PRODUCT CHANGE NOTIFICATION (PCN)

AMJE0909-0500-BKB-24
MODULAR CABLE

CHANGE NOTIFICATION: PCN 20220509_AMJE0909-0500-BKB-24

AMJE0909-0500-BKB-24 OLD VERSION

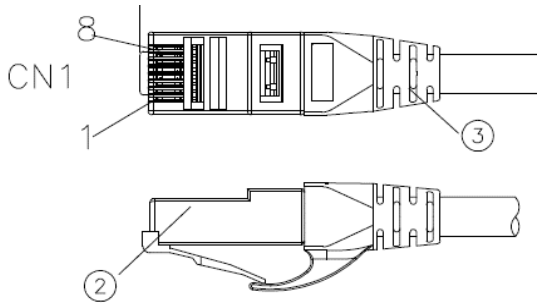
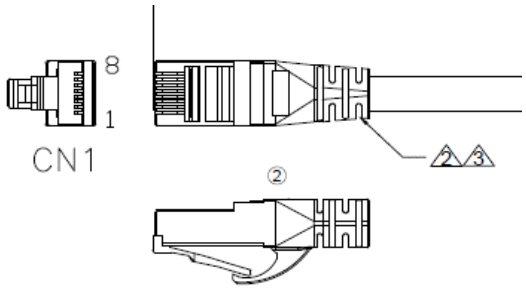
③	Molding	PVC 45P Color: see order code	NA	KG
②	CONNECTOR	RJ45 8P8C two fork Short type 3u" gold plated	2	PCS
①	CABLE	CAT6 UTP (24AWG*1PR)*4+PVC OD=5.8±0.3MM Color: see order code	NA	MM
NO:	NAME	DESCRIPTION	Q'TY	UNIT

3	Molding	PVC 65P Color: see order code ②	NA	KG
2	CONNECTOR	RJ45 8P8C PLUG 3u" gold plated ②	2	PCS
1	CABLE	CAT6 U/UTP (24AWG*1PR)*4+Cross+PVC Jacket OD=5.8± 0.3MM Color: see order code ②	NA	MM
NO:	NAME	DESCRIPTION	Q'TY	UNIT

Drawing-No.
ASS 7945 CA

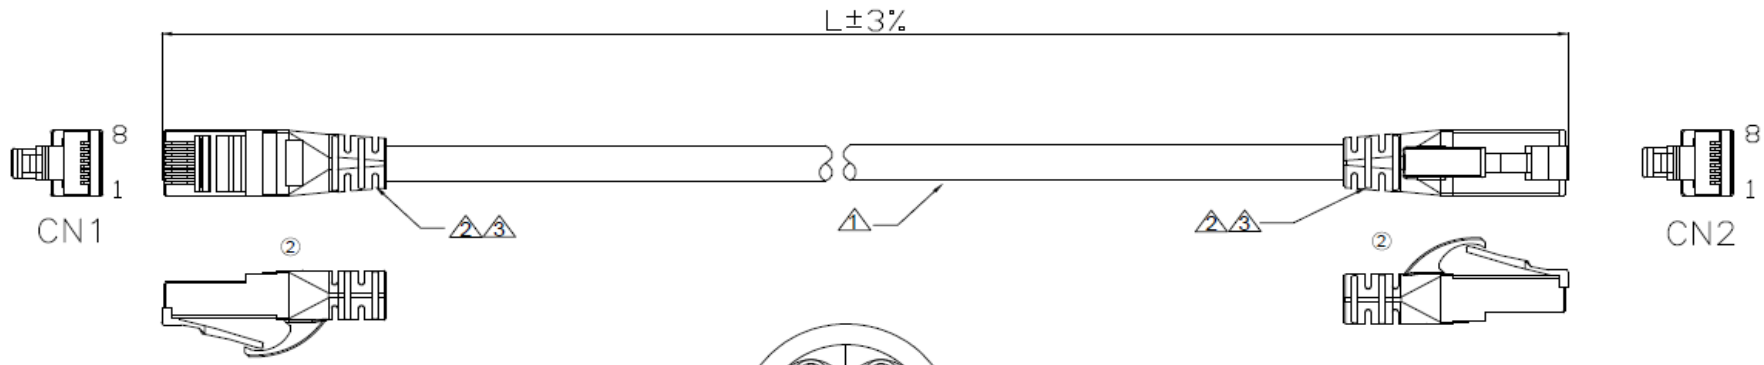
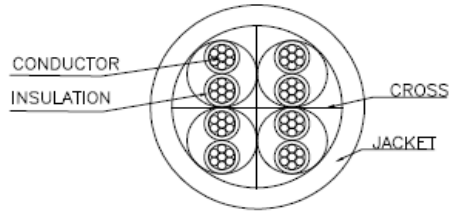
Id.	Modification	Date	Name
②	Change the plant	09.05.2022	Luca
①	Update the WSW order code	02.06.2017	Amy
⓪	Drawn	30.03.2017	Amy

NO:	NAME	DESCRIPTION	Q'TY	UNIT
3	Molding	PVC 65P Color: see order code ②	NA	KG
2	CONNECTOR	RJ45 8P8C PLUG 3u" gold plated ②	2	PCS
1	CABLE	CAT6 U/UTP (24AWG*1PR)*4+Cross+PVC Jacket OD=5.8± 0.3MM Color: see order code ②	NA	MM
